Access Compliance Report

Public Rights-of-Way

(Curb Ramps)

Intersection ID: 12285	Main Street: W_TRADE_ST	Cross Street: N_TRYON_ST	Location: W
ADA ID: EBD348F36828	Ramp Type: Perp	Initial Pass/Fail: Fail	Overall Compliance: No
Severity Score: 12.5			
Codes/Mitigation Info/Possible Solution		Field Measurements/Component Compliance

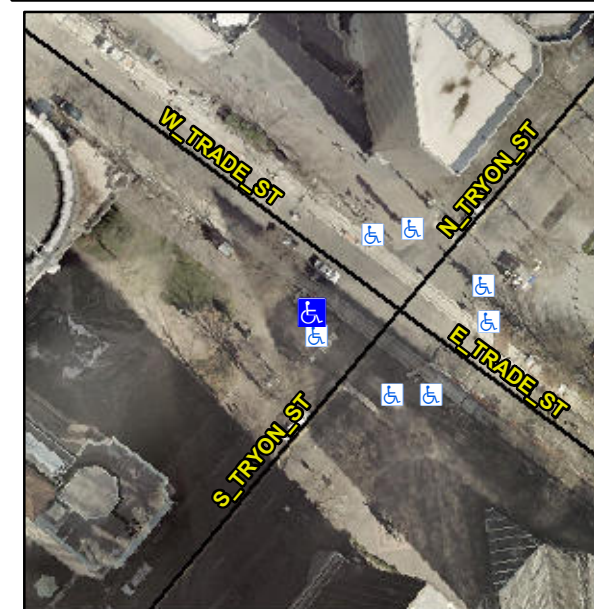
Not Found, R304.2.2

Compliance	Description	Data	Compliance	Description	Data
N/A	Ramp Length (in)	24.0	No	Ramp Slope (%)	10.2
Yes	Ramp Width (in)	48.0	Yes	Ramp XSlope (%)	0.4
N/A	Flare Type LT	N/A	N/A	Flare Type RT	N/A
N/A	Flare Slope LT (%)	N/A	N/A	Flare Slope RT (%)	N/A
N/A	Flare Traversable LT?	N/A	N/A	Flare Traversable RT?	N/A
N/A	Landing Length (in)	N/A	N/A	DWS Provided?	N/A
N/A	Landing Width (in)	N/A	N/A	DWS Contrast?	N/A
N/A	Landing Slope (%)	N/A	N/A	DWS Length (in)	N/A
N/A	Landing X Slope (%)	N/A	N/A	DWS Full Width?	N/A
N/A	Landing Curb? (Y/N)	N/A	N/A	DWS Offset (in)	N/A
N/A	Shared Landing?	N/A			
N/A	Gutter Ponding?	N/A	N/A	Gutter Slope (%)	N/A
N/A	Gutter Lip Ht (in)	N/A	N/A	Gutter X Slope (%)	N/A
N/A	Painted X Walk1?	Yes	N/A	Painted X Walk2?	N/A
	X Walk 1 Direction	To NE		X Walk 2 Direction	N/A
N/A	X Walk 1 Width (in)	114.0	N/A	X Walk 2 Width (in)	N/A
	X Walk 1 Slope (%)	1.3		X Walk 2 Slope (%)	N/A
	X Walk 1 X Slope (%)	0.8		X Walk 2 X Slope (%)	N/A

Remove & Replace Entire Ramp.
